Department of Natural Resources and Parks  
Wastewater Treatment Division

### North Mercer Island Interceptor and Enatai Interceptor Upgrade Project – Response to City of Mercer Island Request for Information (PAE19-001, CAO19-020, and SHL19-019)

**Table 1. Summary of Comments and Revised Materials for the Mercer Island Land Use Permit Application**

**Attachment 1:  
North Mercer Pump Station Gross Floor Area  
and Lot Slope Calculations**

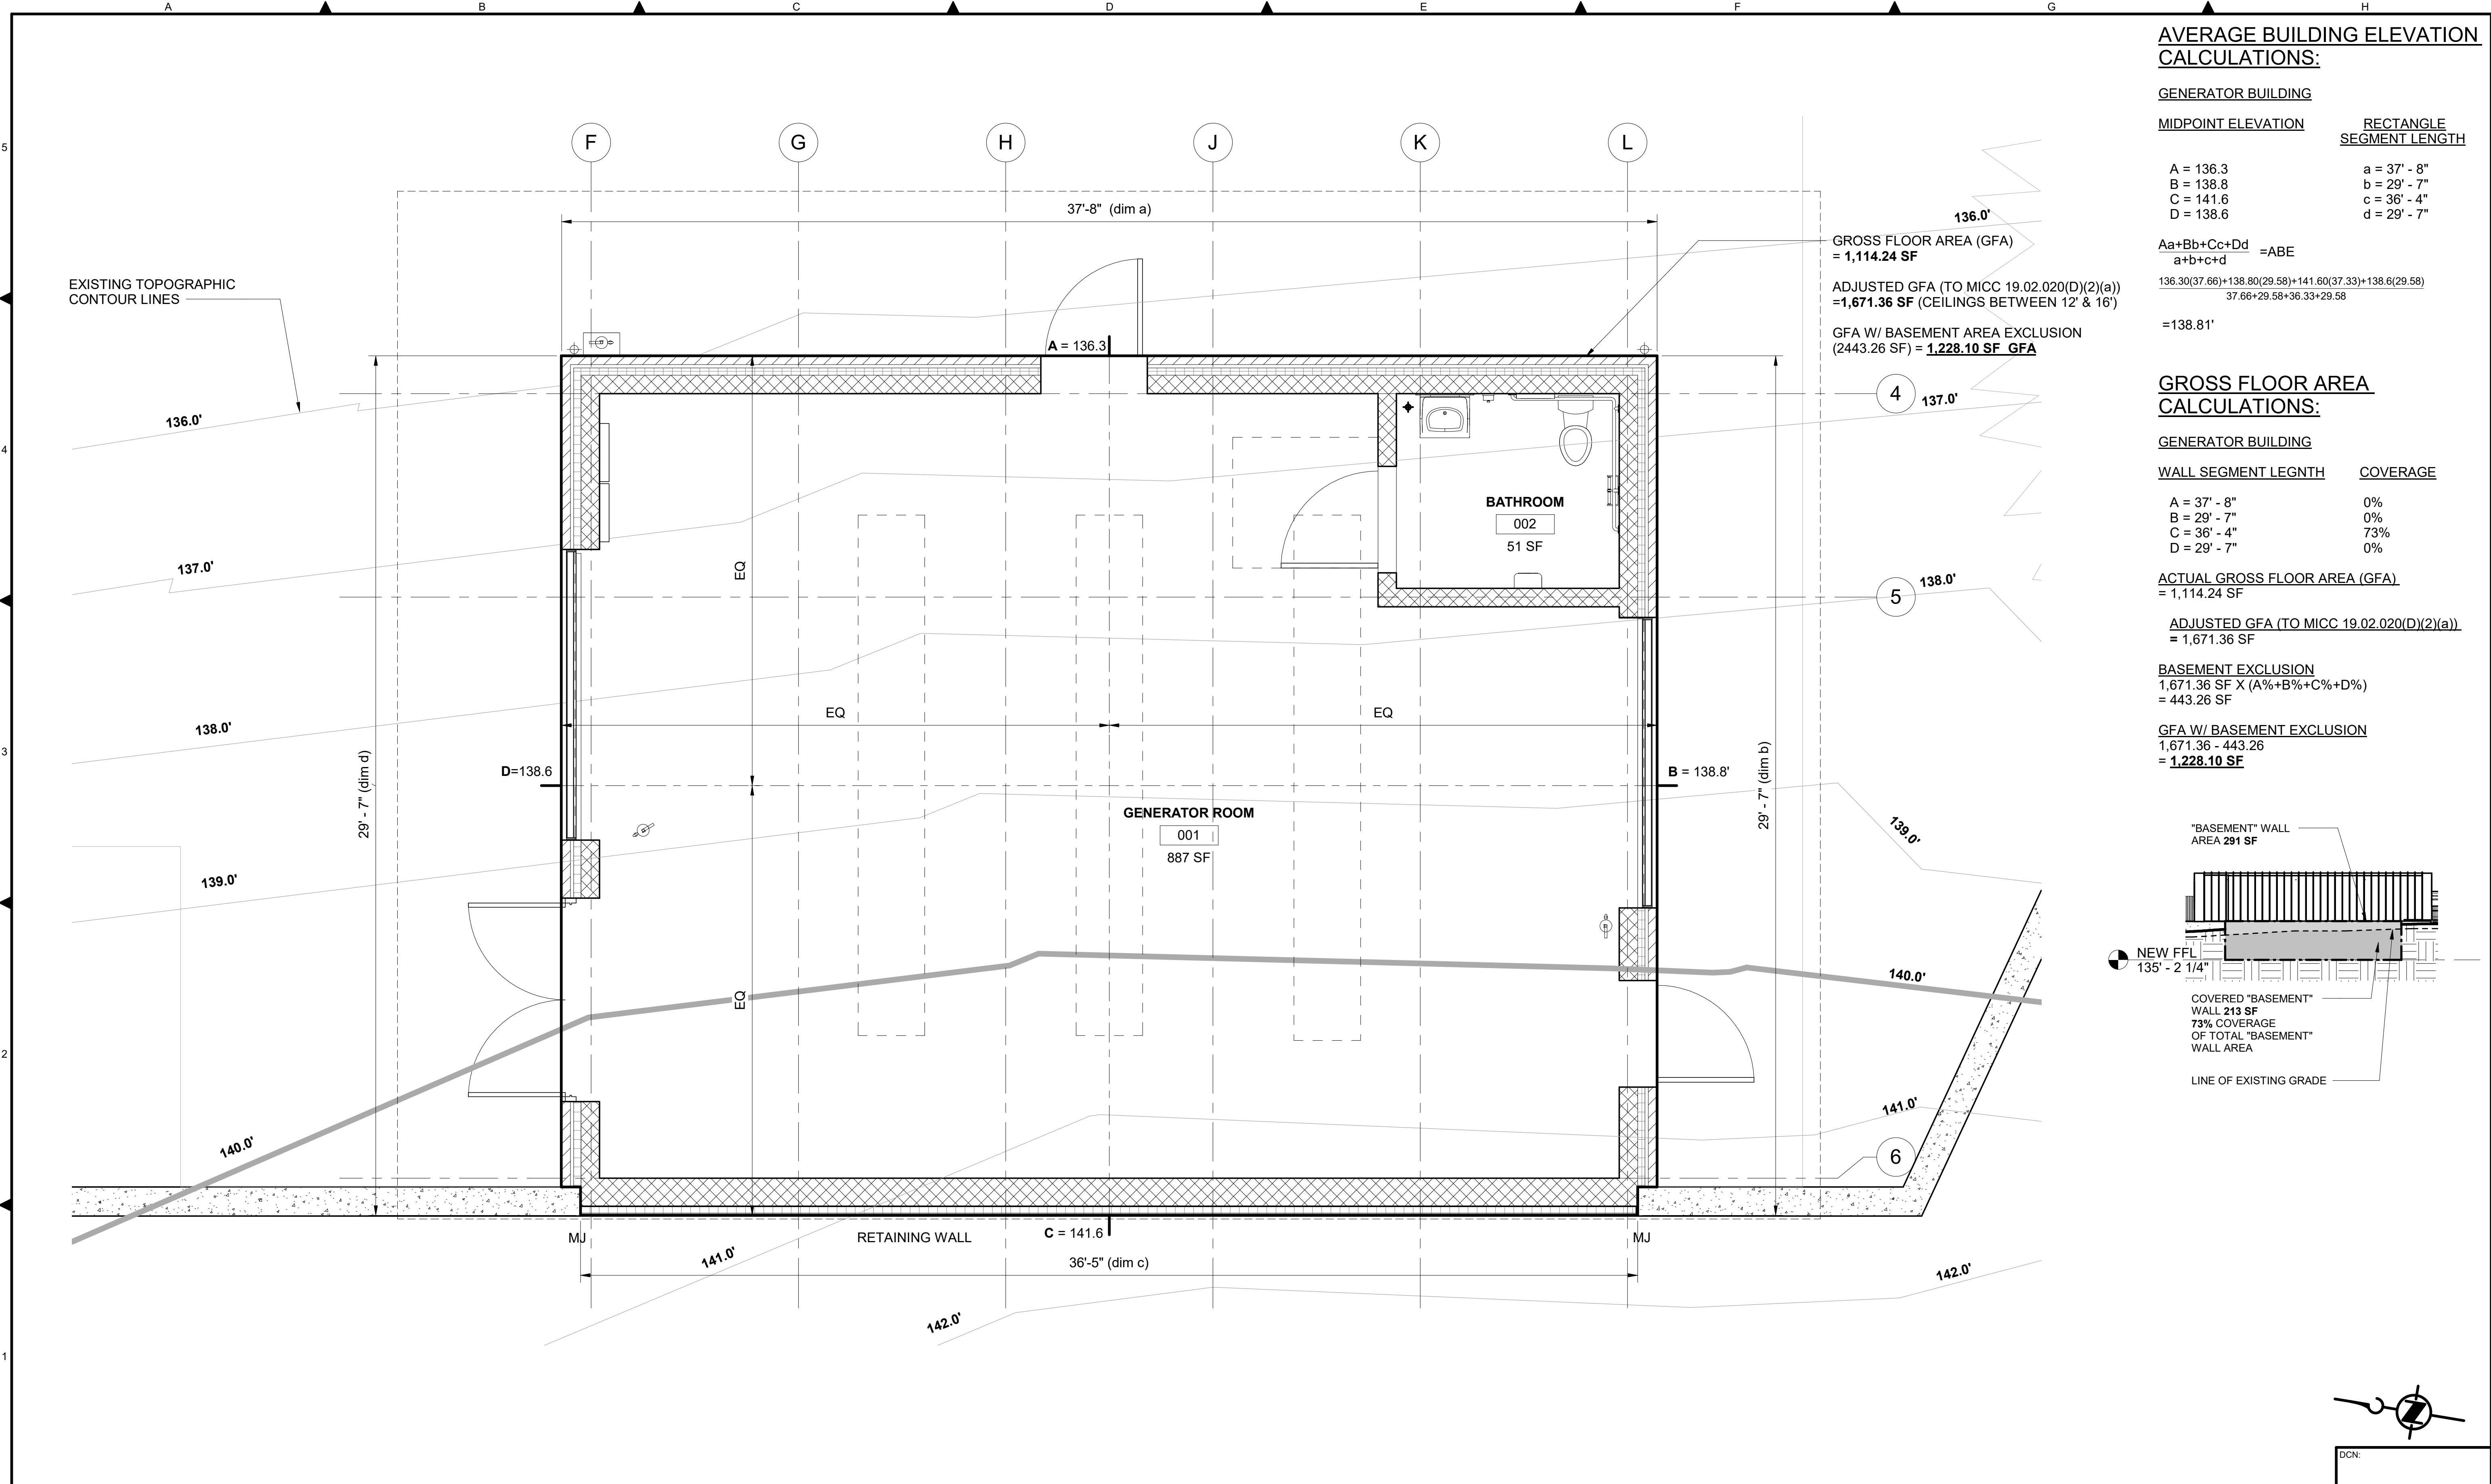
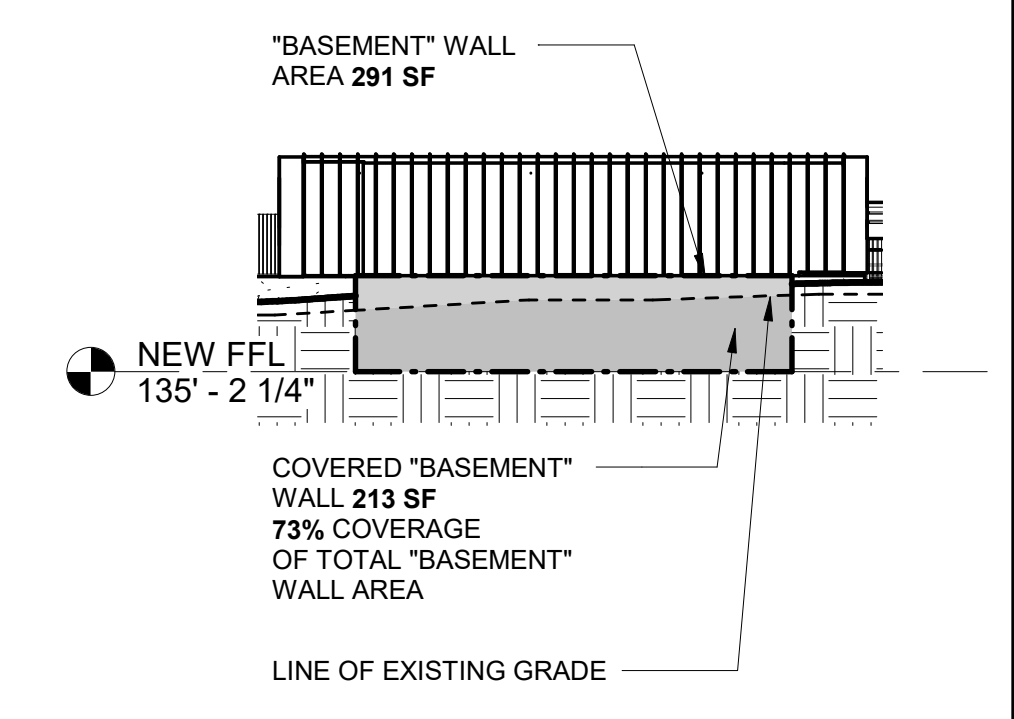
**Mercer Island Comment:** Please calculate the Gross Floor Area (GFA) of the existing pump station and proposed generator building using the definition of Gross Floor Area in MICC 19.16.

**Response:** *The GFA, per MICC 19.02.020(D)(1), for the proposed NMPS generator building is 1,376 square feet (SF). This is excluding the Basement Floor Area, per MICC 19 Appendix B. The existing pump station has a GFA of 1,804 SF for the one level above grade (with 150% allowance for the portion of a room with ceiling heights of 12 feet to 16 feet measured from the floor surface to the ceiling, per MICC 19.02.020(D)(2)(a)). The existing floors that are entirely below grade have been excluded as these would be deducted under the Basement Floor Area deductions anyway. The combined (as proposed) GFA for NMPS is 1,228 SF + 1,804 SF = 3,032 SF. This is below the 5,000 SF limit allowed within the R-8.4 zoning restrictions.*

*Please refer to Attachment 1 for a visual of this calculation.*

**FIGURE 1**

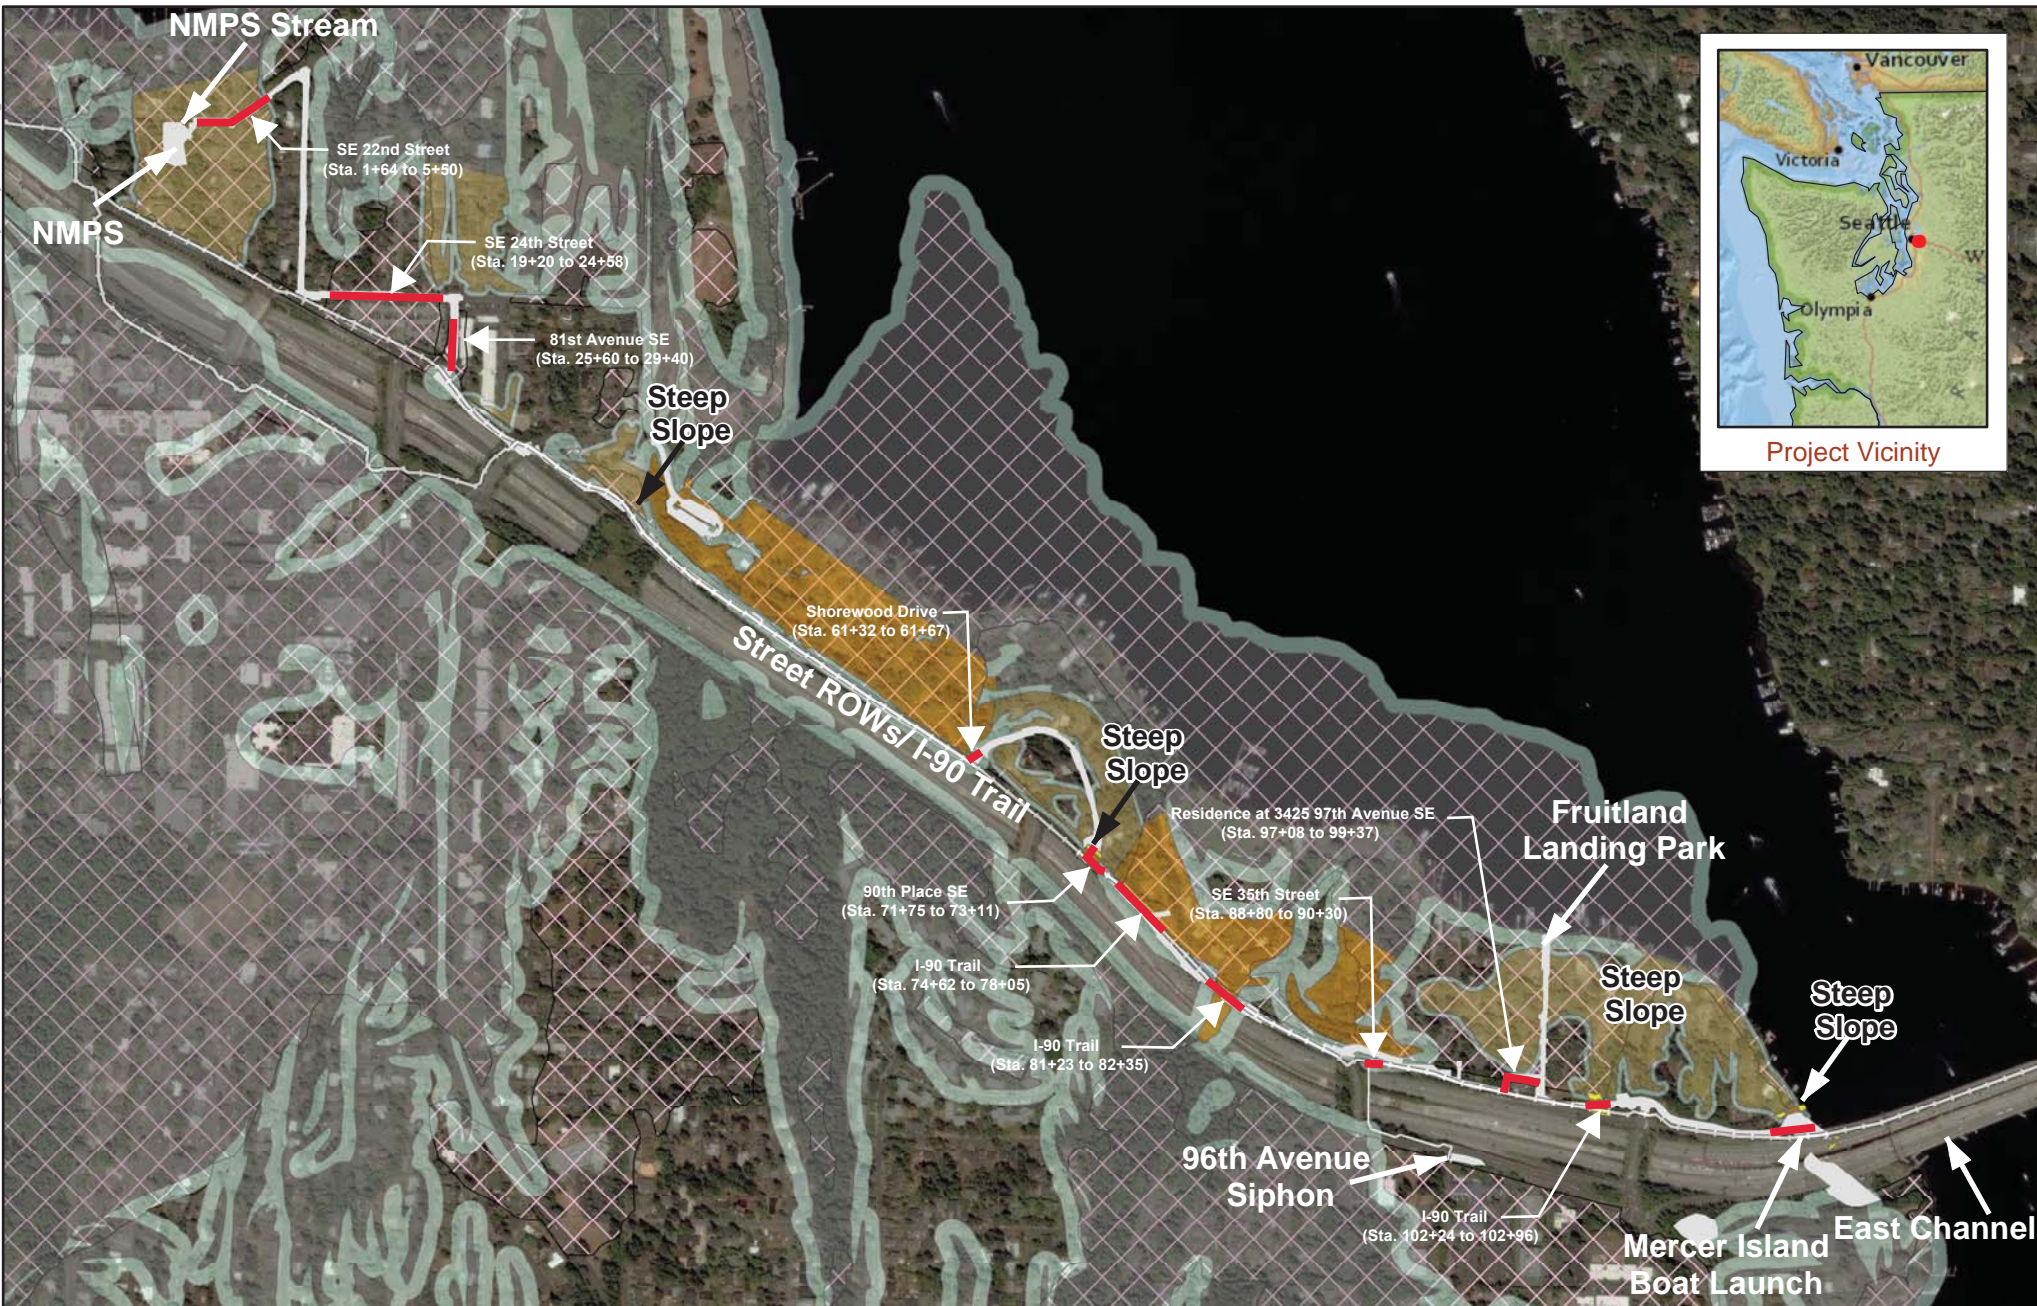
**Mercer Island Comment:** Provide a supplemental letter or report from the geotechnical professional to address code criteria pertaining to geologically hazardous areas, including MICC 19.07.160(B)(2), 19.07.160(B)(3), and MICC 19.07.110(B)(11).

**This is a summary of the comment from Wood:** Because Confluence (not Shannon & Wilson) prepared the Critical Areas Study, there needs to be a supplemental letter/ report from the geotechnical professional to address specific items pertaining to geologically hazardous areas. This includes the following:

**Response:** *Attachment 2 is a memorandum that provides responses from Shannon & Wilson associated with construction within geologically hazardous areas. The geotechnical professional reviewed the appropriate Mercer Island code and design to confirm that the design is both consistent with MICC and the original recommendation within the GDM. Attachment 2 includes three separate memorandums by the geotechnical professional: (1) along the conveyance alignment (pp. 3-14), (2) NMPS (pp. 15-16), and (3) LS11 (pp.17-19).*

As discussed above, there are six sections of the conveyance alignment that are within designated landslide hazard areas. These sections include Station (Sta.) 1+64 to 5+50, Sta. 71+75 to 73+11, Sta. 74+62 to 78+05, Sta. 81+23 to 82+35, Sta. 89+87 to 90+30, and Sta. 102+24 to 102+96. The locations of these sections are shown in Figure 1.

As discussed earlier, in addition to landslide hazard areas, there are six sections of the alignment that are within seismic hazard areas, including Sta. 1+64 to 5+50, Sta. 19+20 to 24+58, Sta. 25+60 to 29+40, Sta. 61+32 to 61+67, Sta. 88+80 to 90+30, and Sta. 97+08 to 99+37. The locations of these sections are shown in Figure 1.
